## **REMARKS/ARGUMENTS**

# Annotated Sheet Showing Changes

FIG. 12

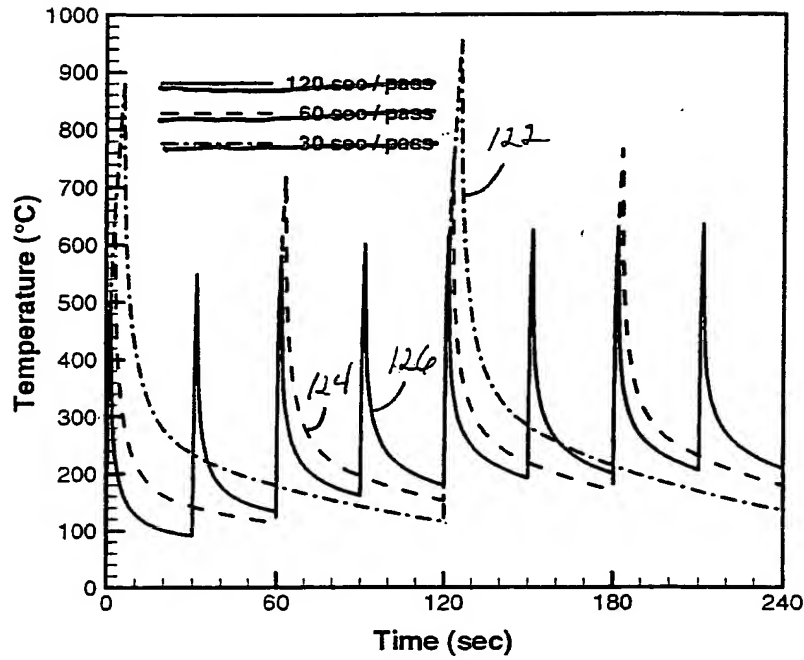
FIG. 12 incorrectly identified curve 122 as representing a traverse speed of 30 seconds per pass, and curve 126 as representing a traverse speed of 120 seconds per pass. As is evident from the figure, the combined dotted and dashed curve, 122, indicates a time of 120 seconds to complete a pass (i.e., temperature returns to a minimum), whereas solid curve 126 is shown indicating a time of 30 seconds to return to a temperature minimum, i.e. to complete a pass. Applicants have removed the incorrect legend from the figure, and corrected paragraph 0064 to accurately identify the data shown in FIG. 12.

FIG. 13

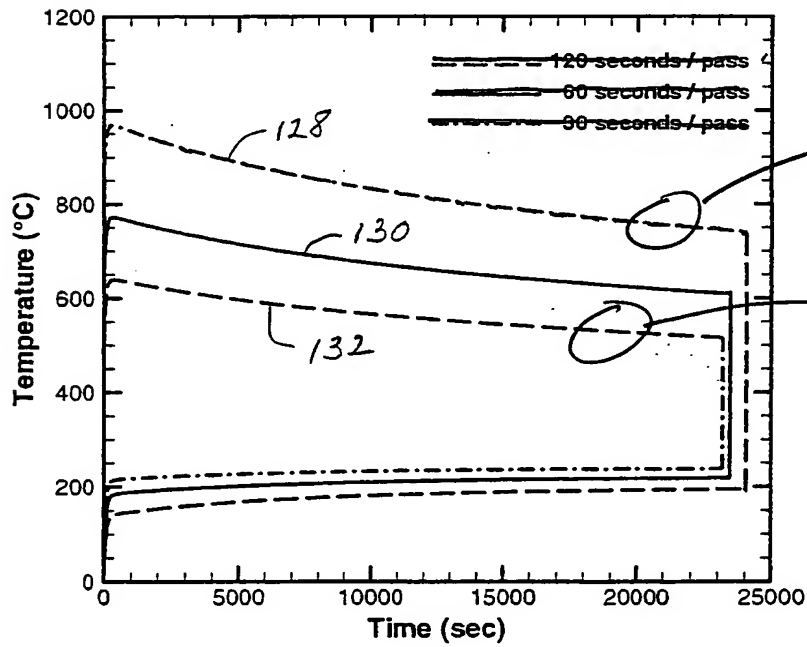
FIG. 13 has been similarly corrected. In accordance with the disclosure of the application, a faster traverse rate (e.g. 30 seconds) results in a lower surface temperature than a slower traverse rate (e.g. 120 seconds). As with FIG. 12, the 120 second and 30 second traverse rate identifications are reversed. Moreover, FIG. 13 as-filed provides ambiguous representation of the curves (note that the top portion of curve 128 is dotted and dashed, whereas the rest is dashed only. Similarly, curve 132 is a combination of dashed and dotted, and dashed only.). Applicants have removed the incorrect legend from FIG. 13, and corrected the text of paragraph 0064 to accurately reflect the data shown in the figure.
